**Table of Contents for Block at 26<sup>th</sup> street**  
**Heritage Tree Variance Package**

**PROJECT NAME:** Block at 26<sup>th</sup> Street

**SITE PLAN:** SP-2011-0032C.SH

**SUBJECT:** Block at 26<sup>th</sup> Street  
SP-2011-0032C.SH

Exhibit #4

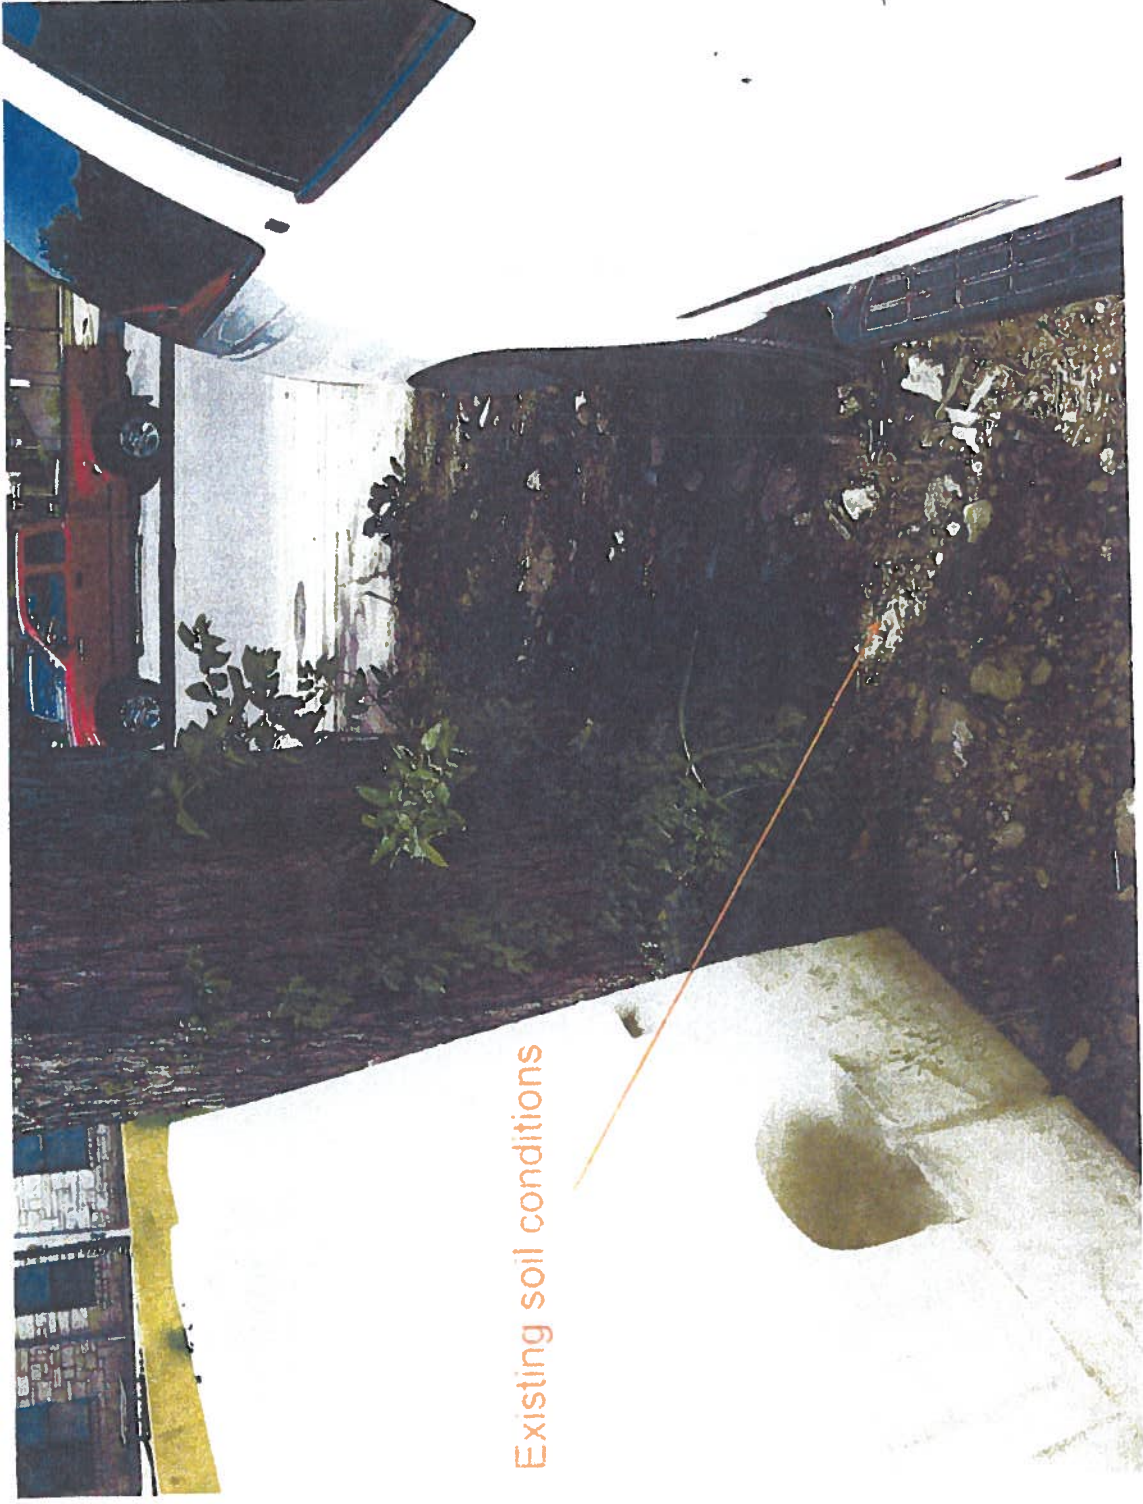
The subject tree is a 30.5 inch diameter at breast height (dbh) Pecan (*Carya illinoensis*). The tree height is 63 feet and the canopy spread is 55 feet (Exhibit 2). The trunk bifurcates into two co-dominate stems at eight feet above grade (Exhibit 3). Storm damage is evident by the presence of broken stems, though no noticeable decay or structural weaknesses are present (Exhibit 4). Minor pruning has occurred for utility clearing and likely from storm damage. There is minor deadwood and tip dieback in the crown though this is not uncommon in *Carya illinoensis* (Exhibit 5). This condition is likely exacerbated by poor soil and extensive compaction in the critical root zone (Exhibit 6). Given the aforementioned conditions, the subject tree is rated 'good' per the City Arborist tree evaluation (Exhibit 7).
